**INTERNATIONAL CODE COUNCIL
2012/2013 CODE DEVELOPMENT CYCLE
Group A (2012)**

**PROPOSED CHANGES TO THE
2012 EDITIONS OF THE**

INTERNATIONAL BUILDING CODE®

**April 29th – May 8th, 2012
Sheraton Dallas Hotel
Dallas, TX**

713.14.1.2 Connections with corridors and other rooms. When a lobby or smoke partitions of Exception 5 in Section 713.14.1, is constructed, corridors shall be permitted to pass through the elevator lobby when the connecting walls and doors are constructed in accordance with this section.

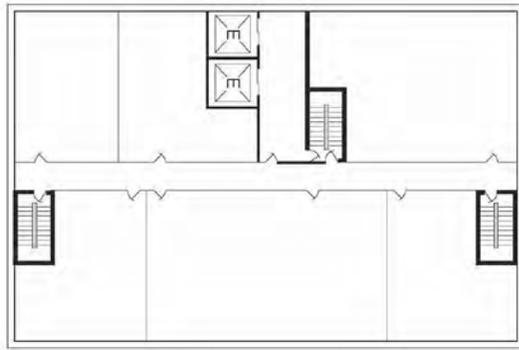
Exception: In Group I-2 occupancies and ambulatory health care facilities, connecting doors for a corridor passing through the lobby need not have latching hardware when in compliance with Section 709.5.

Other rooms or spaces shall be permitted to have doors directly connected to the lobby.

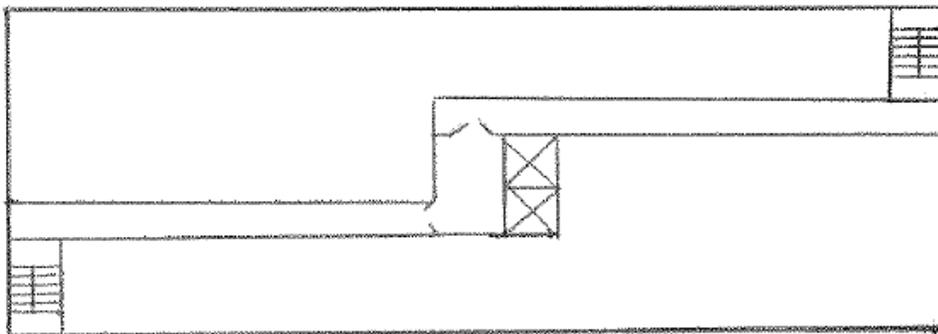
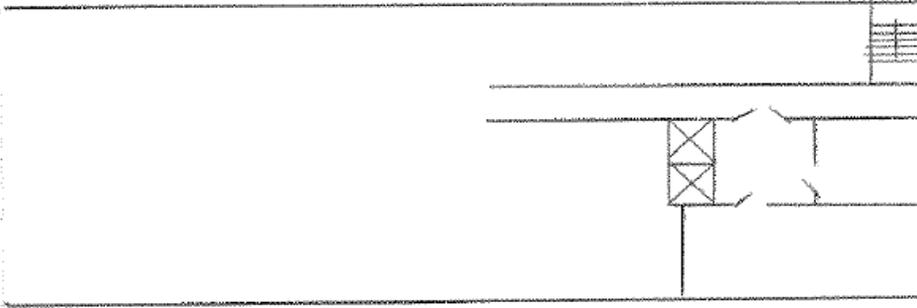
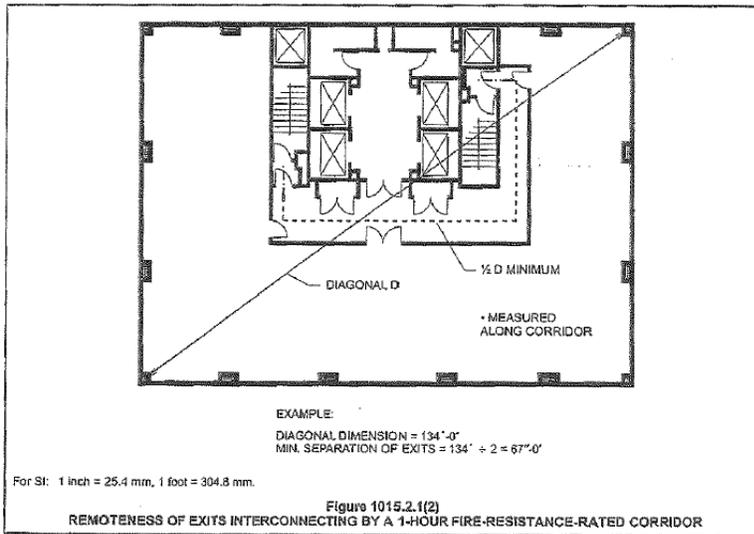
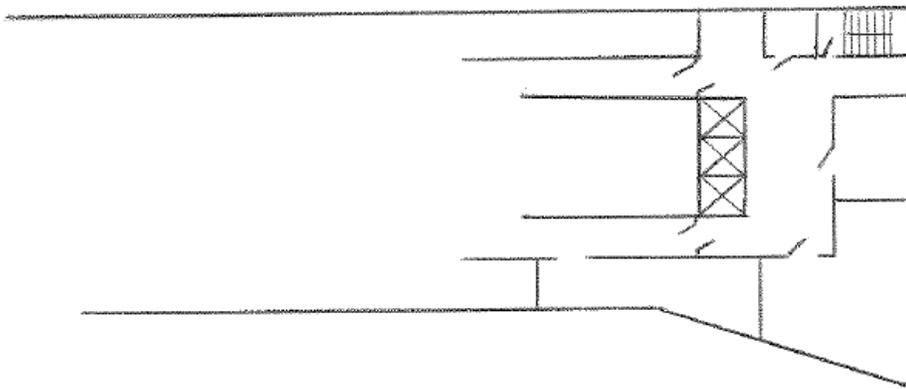
1. Corridor passes through passenger elevator lobby. If provided with access to a stair and proper construction, could this be a Fire Service Access Elevator Lobby and/or an Occupant Evacuation Elevator Lobby?

2. Rooms connect to and exit through elevator lobby. If provided with access to a stair and correct construction, could this be a Fire Service Access Elevator Lobby and/or an Occupant Evacuation Elevator Lobby?

Even the commentary has an example of what appear to be restrooms off an elevator lobby as follows:

3. The following is an example of corridors passing through a lobby, along with rooms with direct connection to lobby, serving as passenger elevator lobby Fire Service Access lobby and/or Occupant Evacuation Elevator lobby. This is an actual design submitted for review.

When this discussion concludes, there should be a clear definition of what is required for lobby protection.

**FIGURE 3007.7.5
FIRE SERVICE ACCESS ELEVATOR SYMBOL**

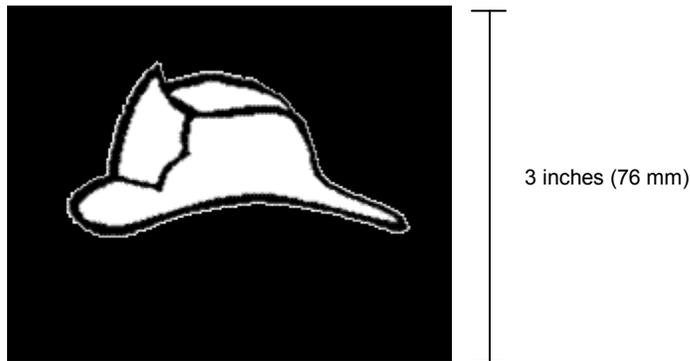
(Add dimensional lines on Figure 3007.7.5 to indicate that it is the rectangular field, not the helmet that has a dimension of 3 inches (76 mm) minimum height.)

Reason: Because the code is printed in black and white, the current text may be read to state that the symbol must always have a white helmet on a black background. This is unnecessarily restrictive, and in fact a red helmet may be the preferred color to harmonize with the buttons on the elevator car operating panel that are regulated by ASME A17.1/CSA B44.

3007.7.5 Fire service access elevator symbol. A pictorial symbol of a standardized design designating which elevators are fire service access elevators shall be installed on each side of the hoistway door frame on the portion of the frame at right angles to the fire service access elevator lobby. The fire service access elevator symbol shall be designed as shown in Figure 3007.7.5 and shall comply with the following:

1. The fire service access elevator symbol shall be not less than 3 inches (76 mm) in height.
2. The helmet shall contrast with the background, with either a light helmet on a dark background or a dark helmet on a light background.
23. The vertical center line of the fire service access elevator symbol shall be centered on the hoistway door frame. Each symbol shall not be less than 78 inches (1981 mm), and not more than 84 (2134 mm) inches above the finished floor at the threshold.
